ARCHITECTURAL DESIGN REPORT

CHIEF MECHANICAL ENGINEER'S(CME) BUILDING

December 2022

1 SITE PLAN
SCALE 1 : 150

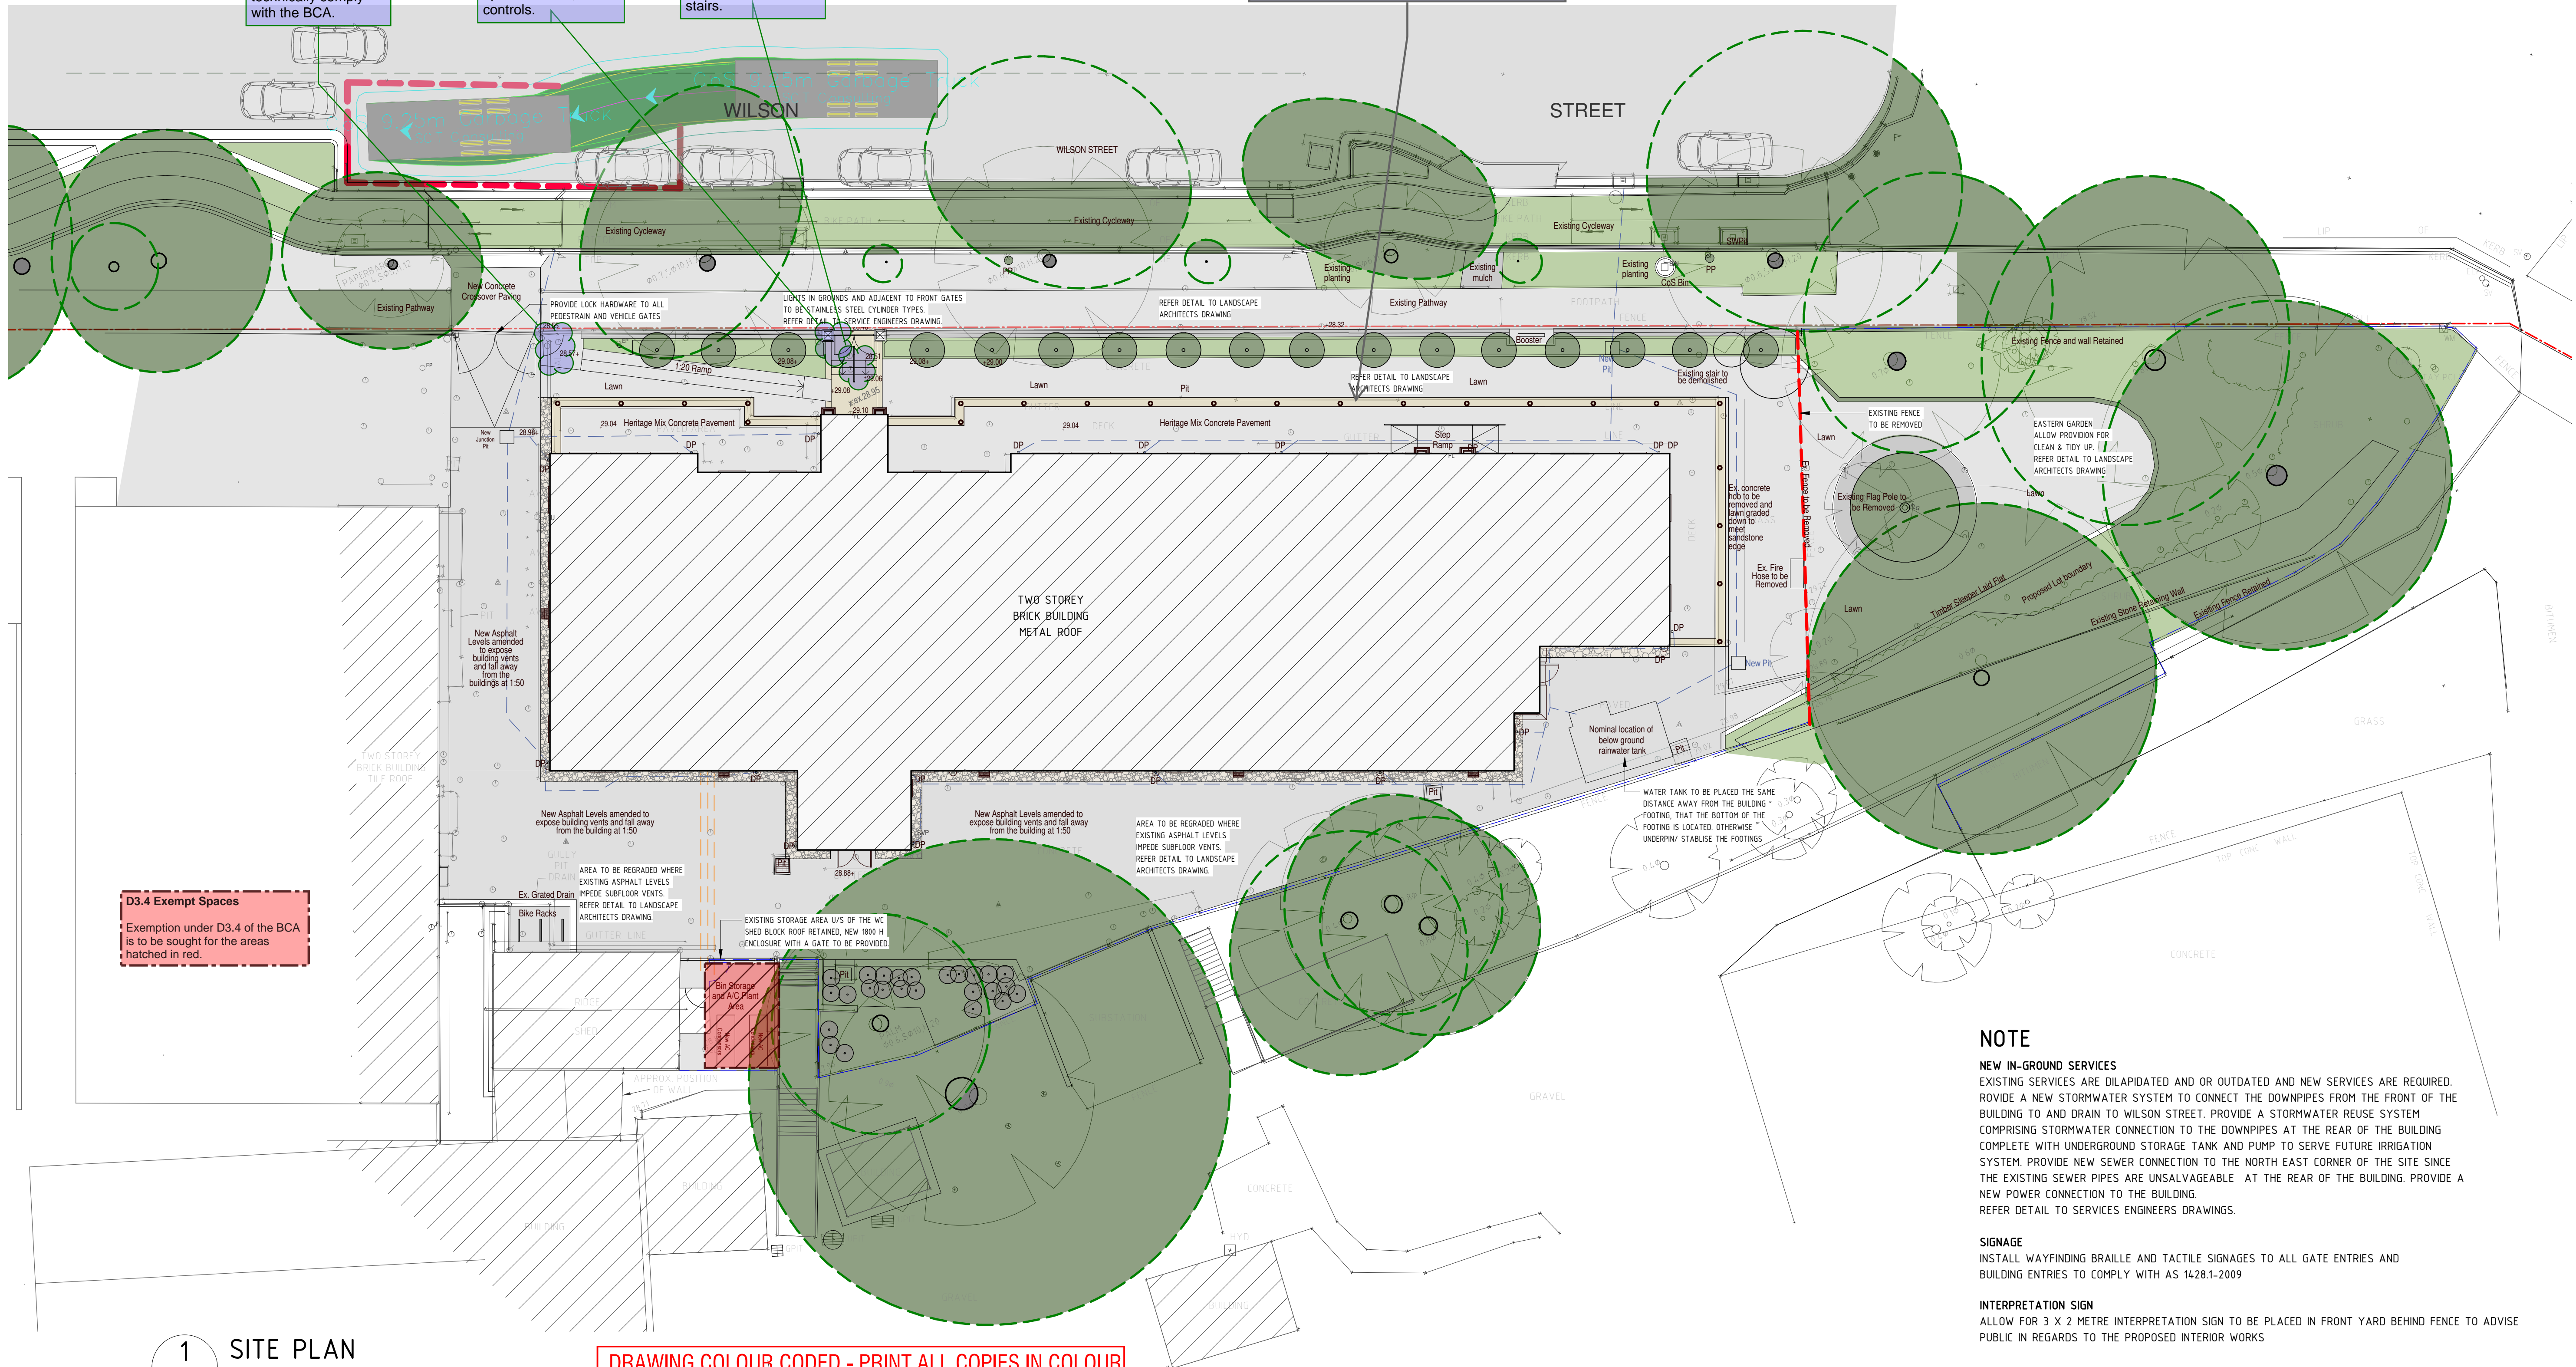
4. Performance Solution
Gate circulation clearances to both gates to be achieved outside of the allotment boundary and therefore do not technically comply with the BCA.

4. Performance Solution
Gates to be operated by dedicated staff given non compliances with operable force, door controls.

2. Performance Solution
The floor or ground surface abutting the sides of the walkway shall provide a firm and level surface of a different material to that of the walkway at the same level of the walkway, follow the grade of the walkway and extend horizontally for a minimum of 600 mm.
